SCHEMATIC CONDUIT DIAGRAM  
 OVER LEWES & REHOBOTH CANAL  
 SAVANNAH ROAD BRIDGE

SAVANNAH ROAD BRIDGE  
 LEWIS I. DEBEL  
 SCALE: AS LISTED  
 DATE: 1/21/83  
 PASCALE LEAF LIGHTING & POWER  
 TUDOR Z ELEC  
 DRAWING NUMBER  
 OFFICE COPY

HARDESTY & HANOVER  
 CONSULTING ENGINEERS  
 W. B. Burgess  
 MAY 2, 1983

DECK POUR-1-REVISED  
 TUDOR ELECTRIC  
 DRAWING NUMBER: DP-1-R

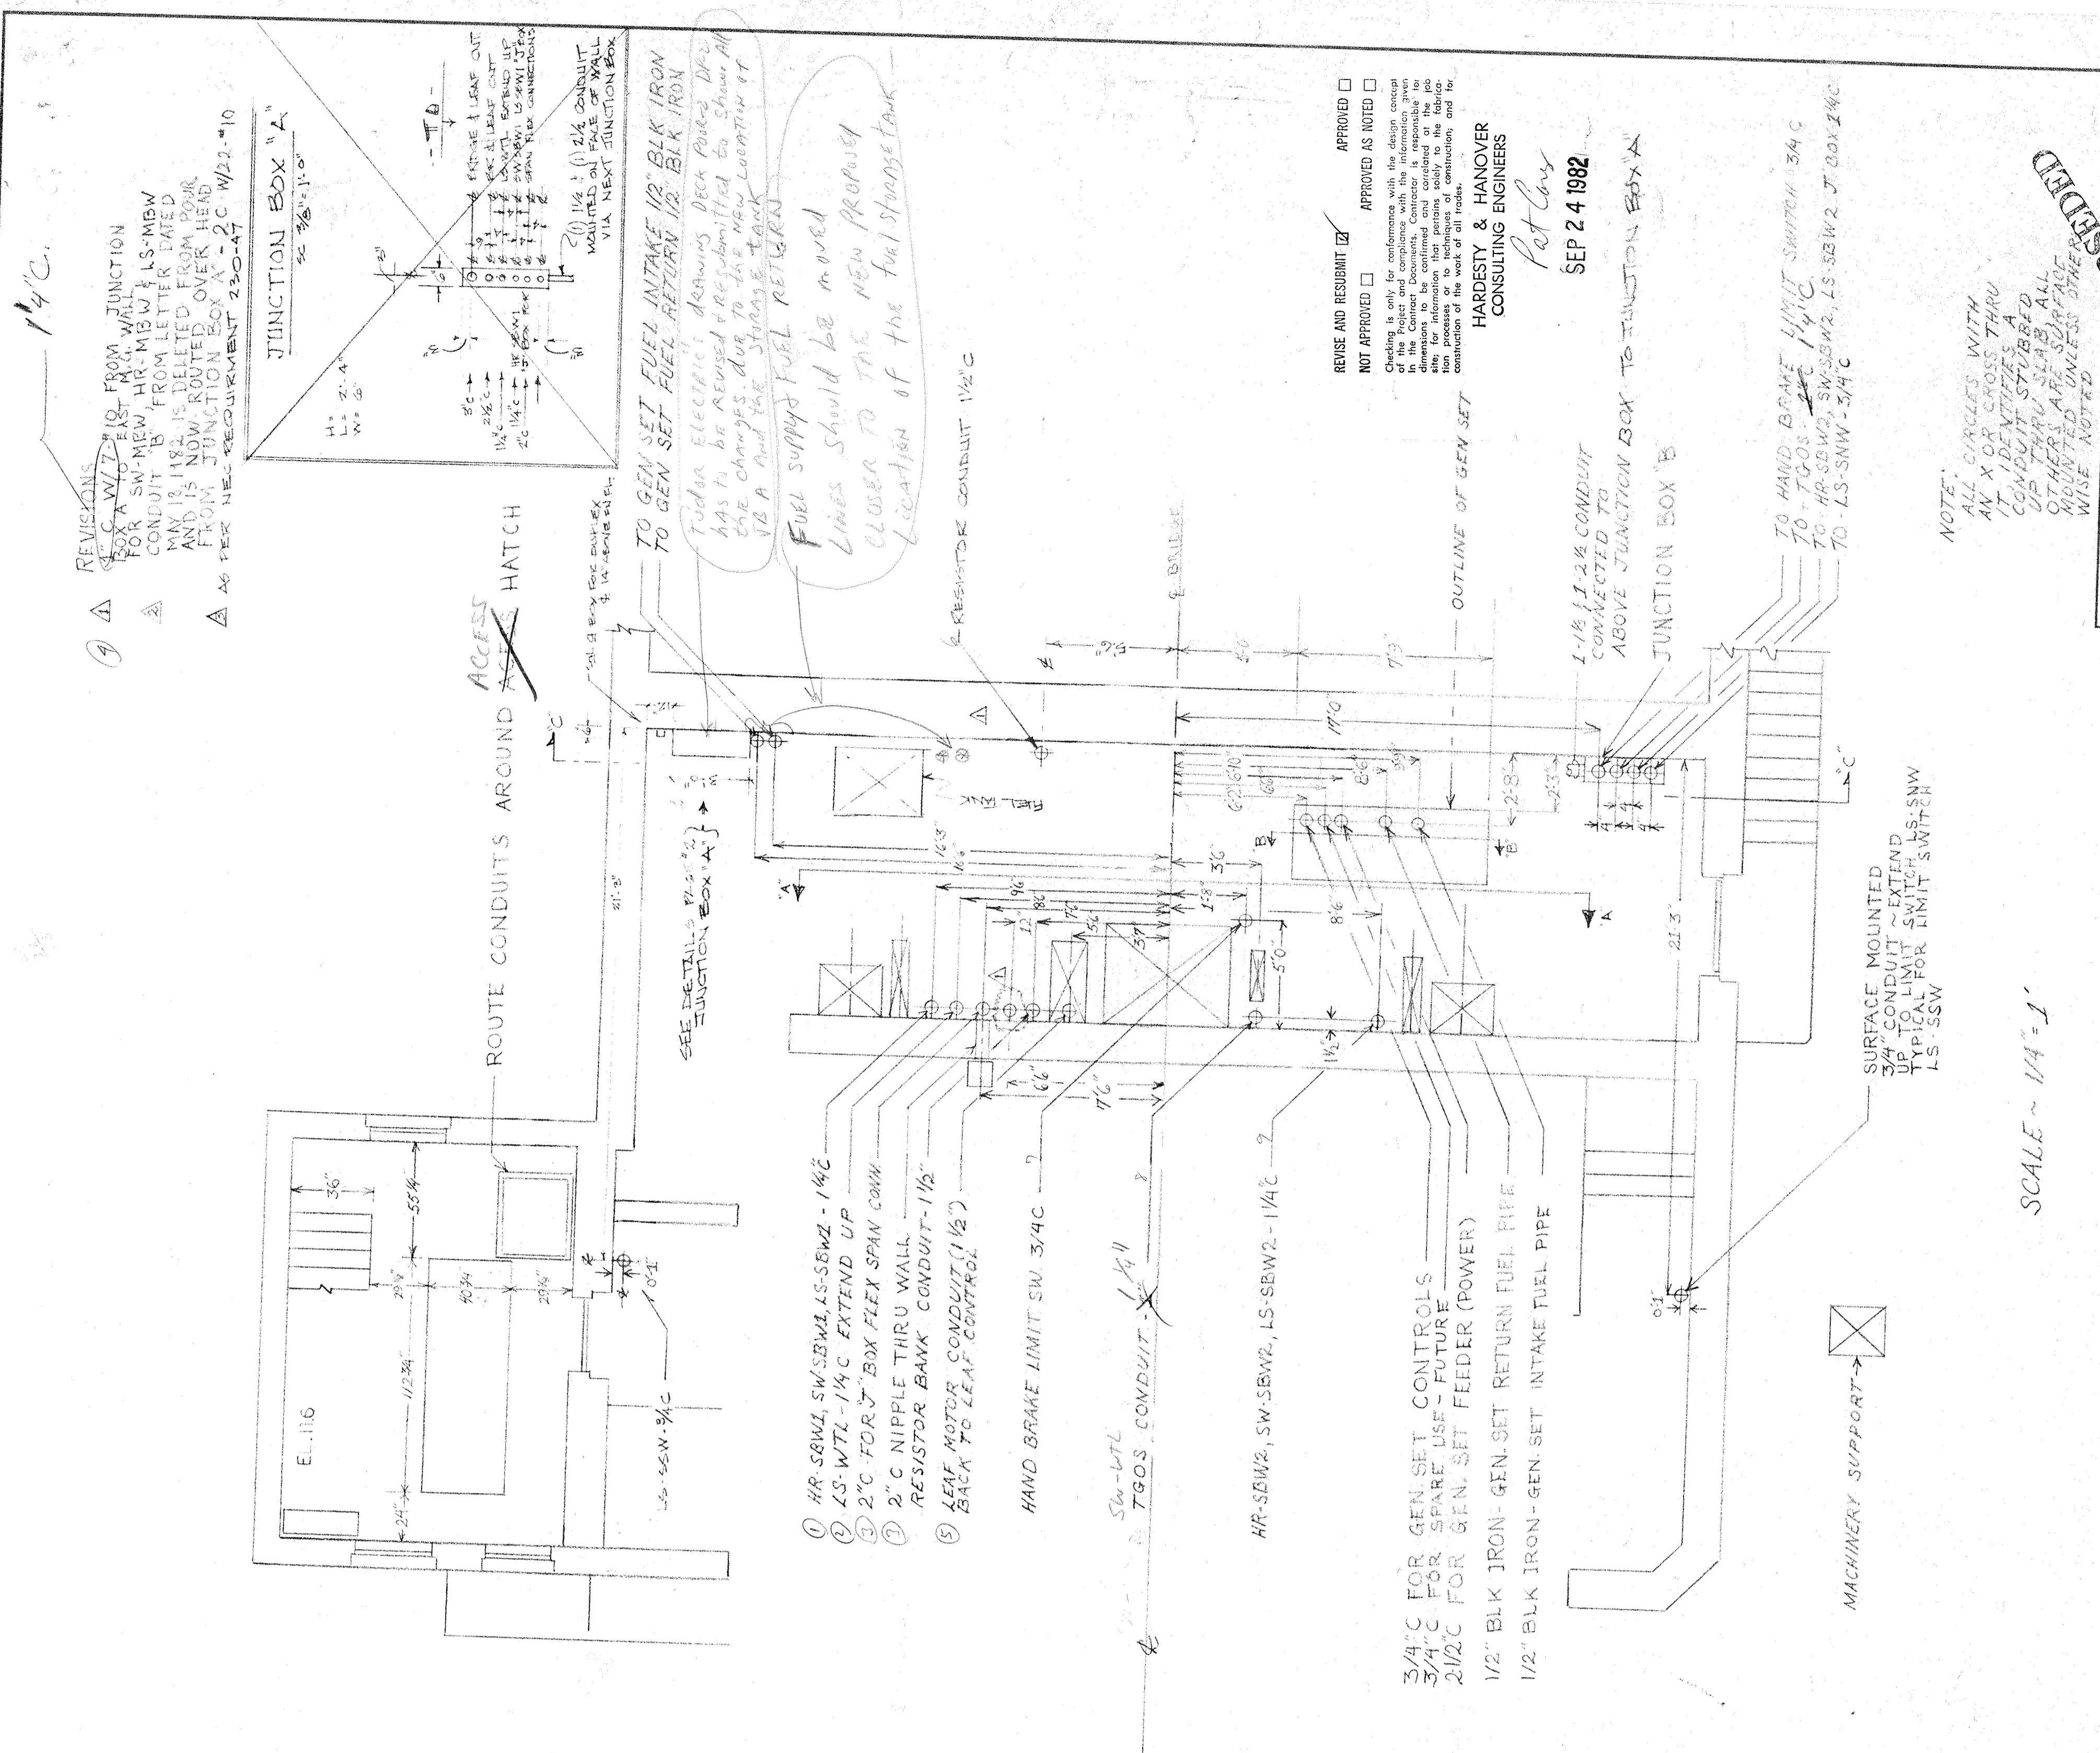
NOTE A: INCORRECT ROUTING OF CONDUIT FROM PHOTO CELL TO ENTRY HOUSE VIA ROOF. SEE EL. 10.0 SHEET 60 OF CONTRACT DRAWINGS.

NOTE B: PHOTOCELL TO BE MOUNTED ON ROOF.

EAST WALL OF M.G. WEST LEAF  
AS LOOKING FROM INSIDE M.G.  
SCALE ~ 1/4" = 1 FT

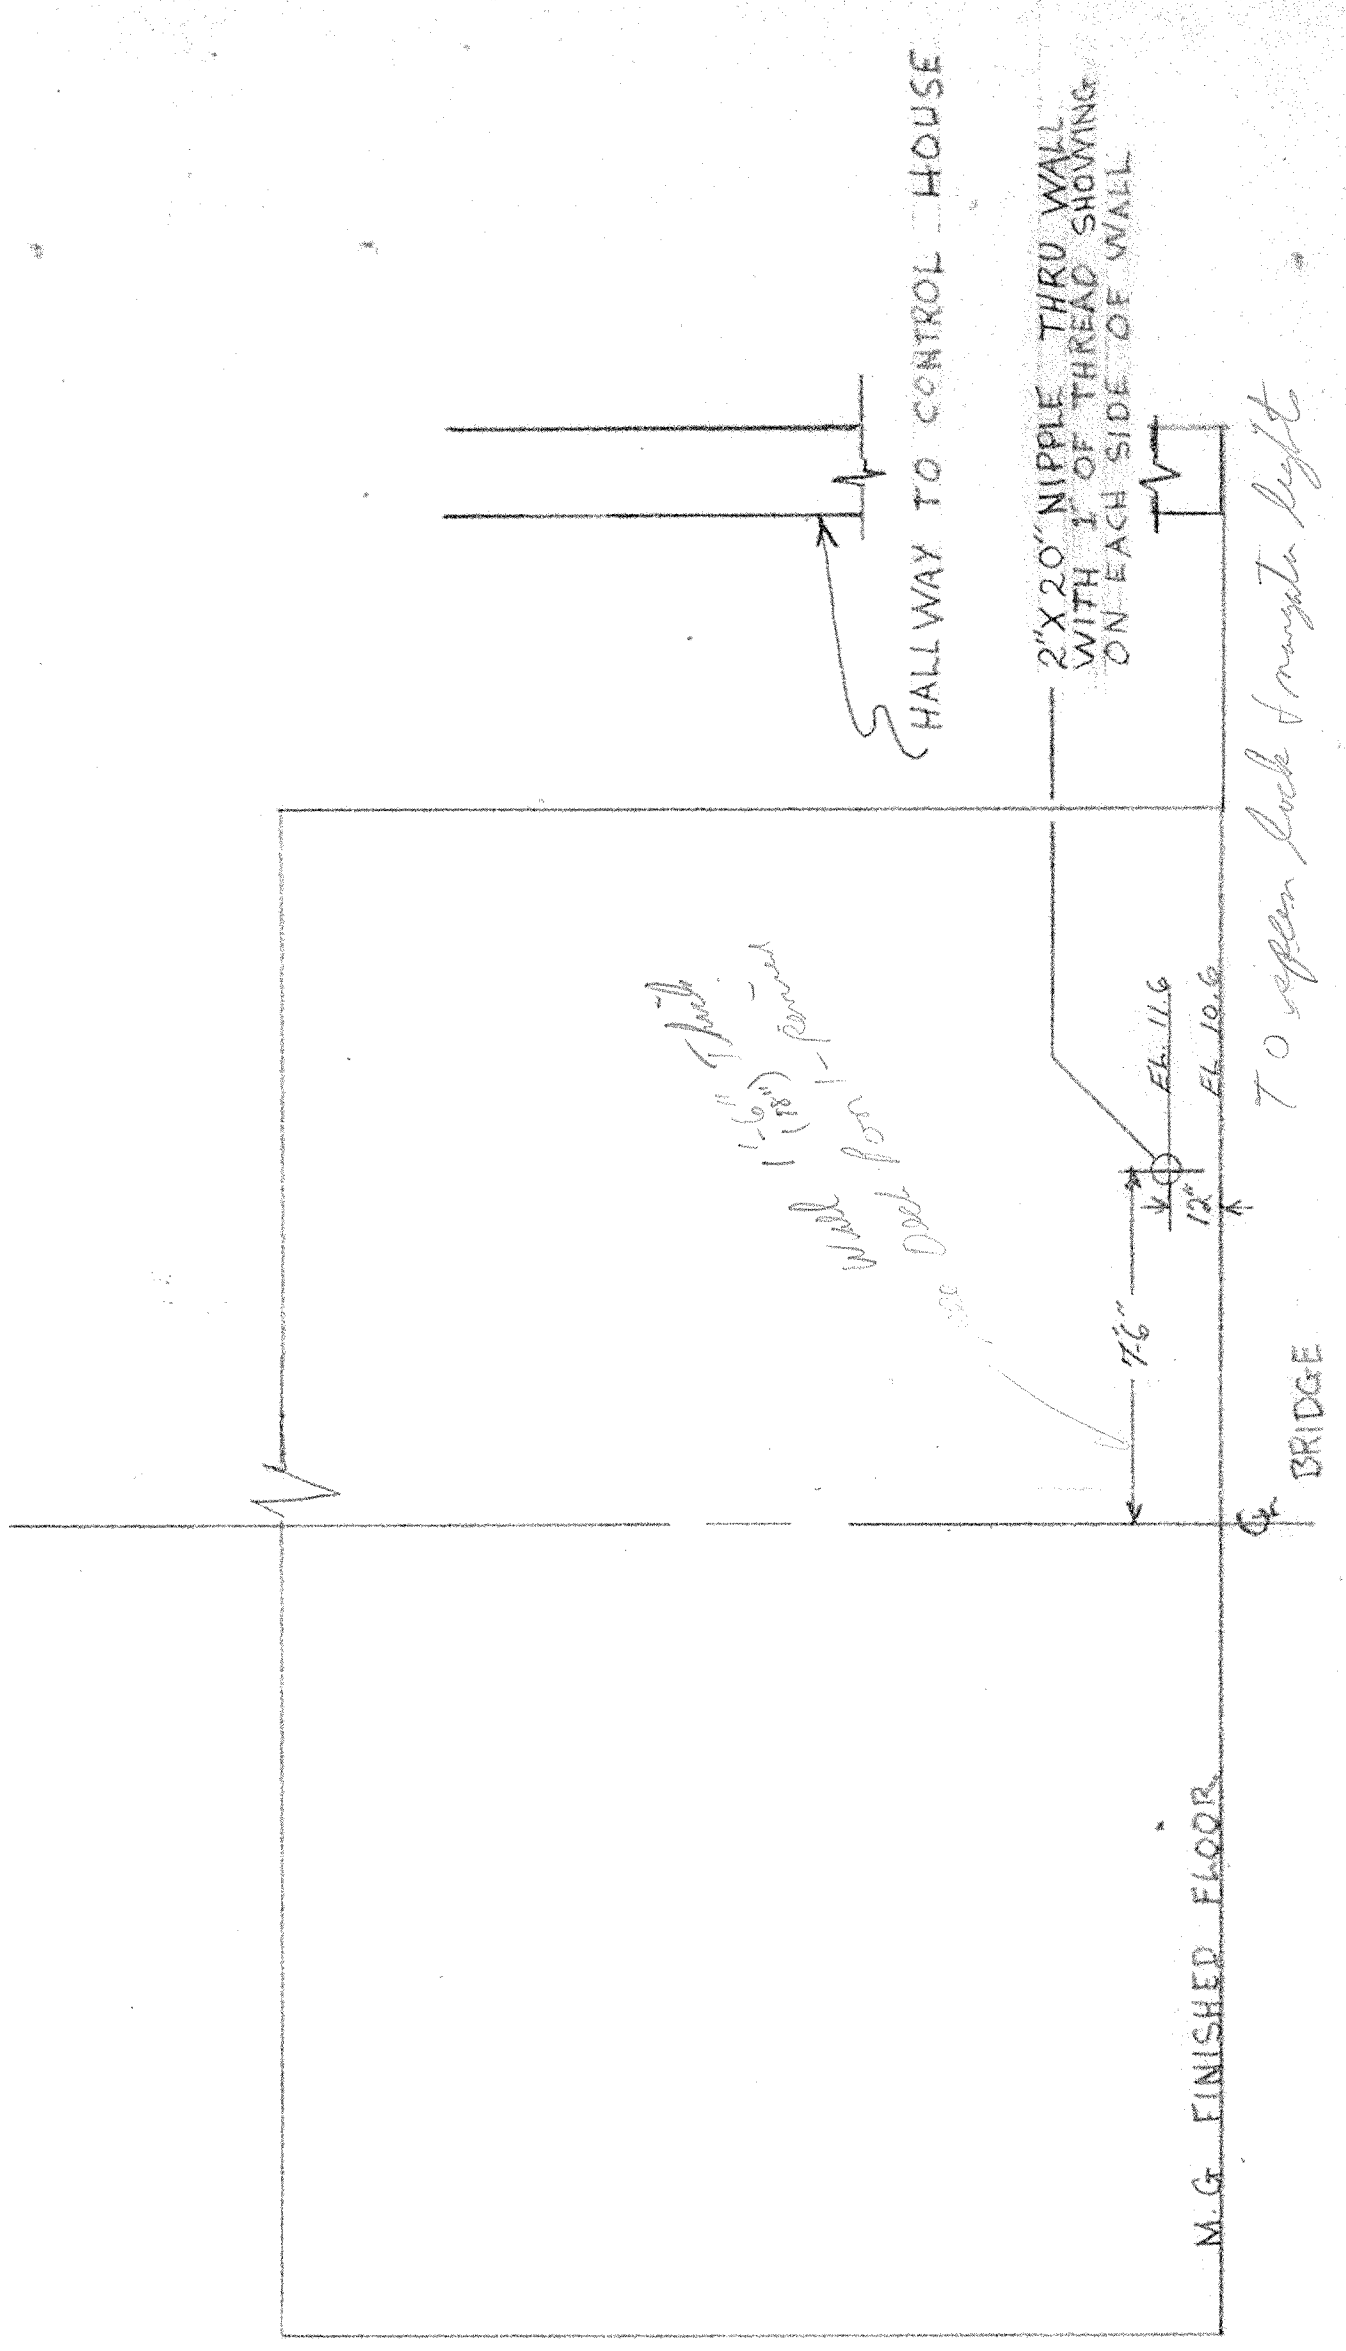
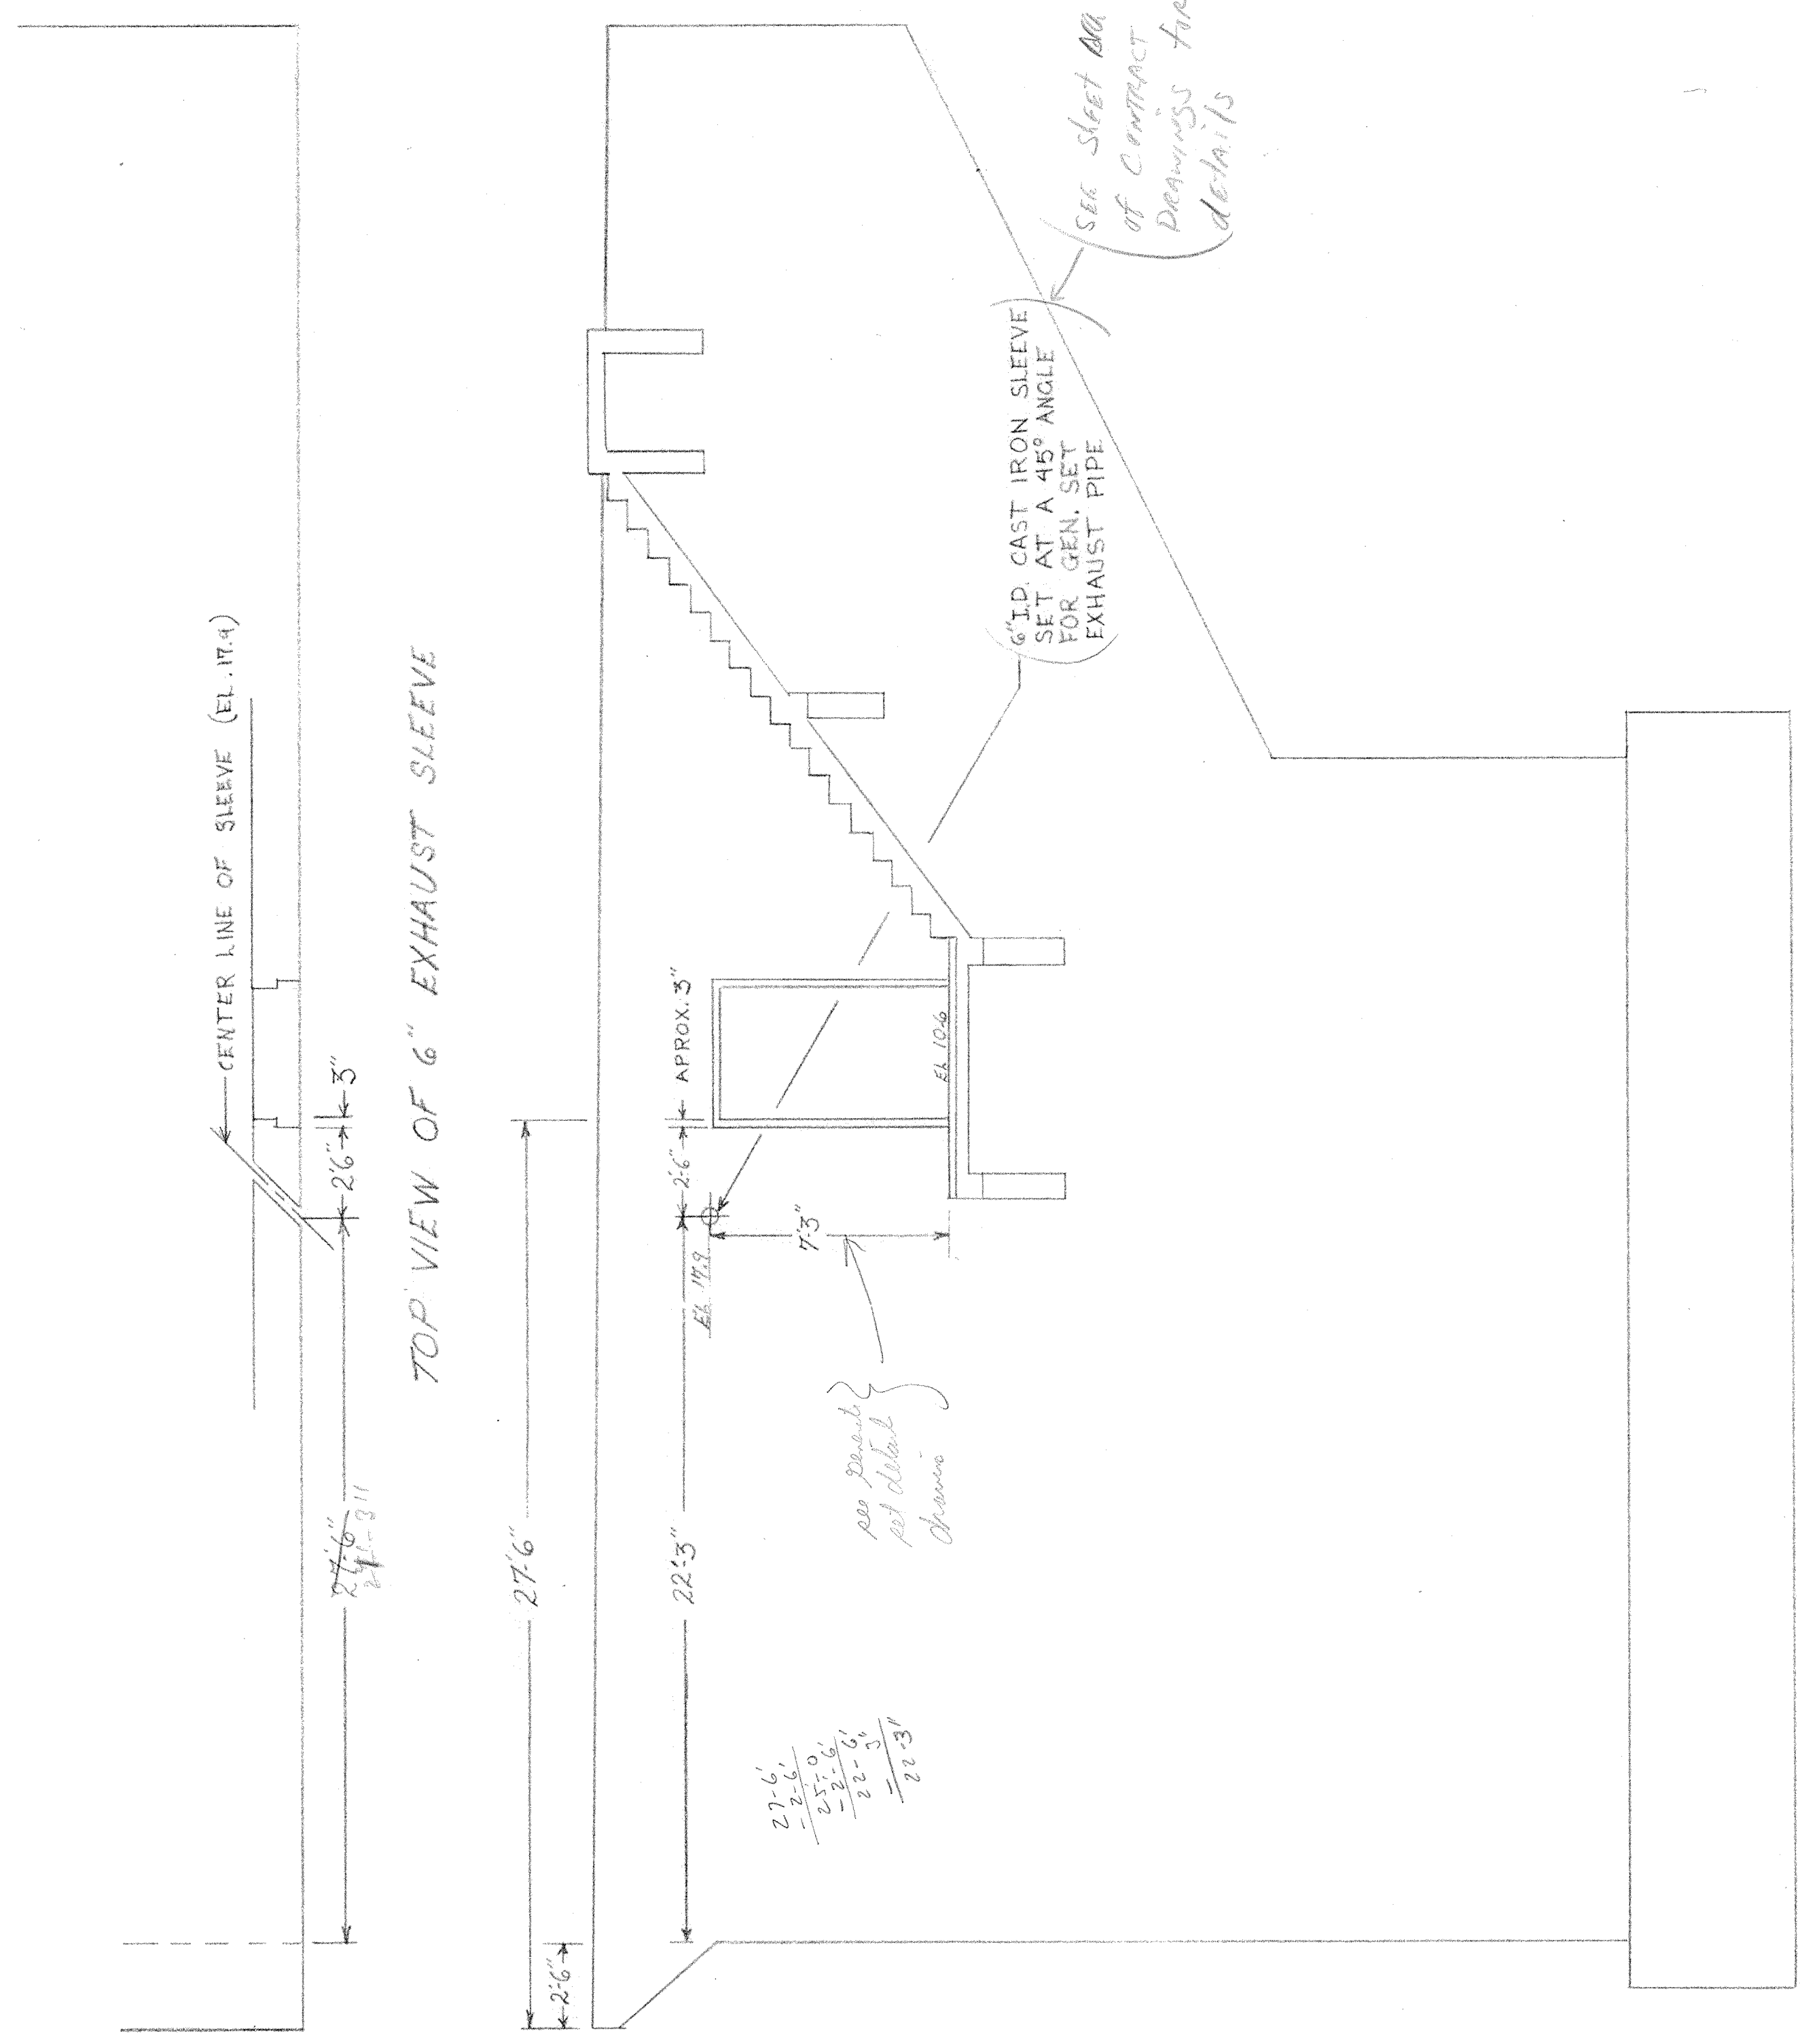
*Incorrect Routing!*  
Photo cell to be mounted  
on roof, with conduit  
passing through the roof  
of the house - And not  
through this wall. See  
Sheet No. 60 of Contract  
Drawings for details
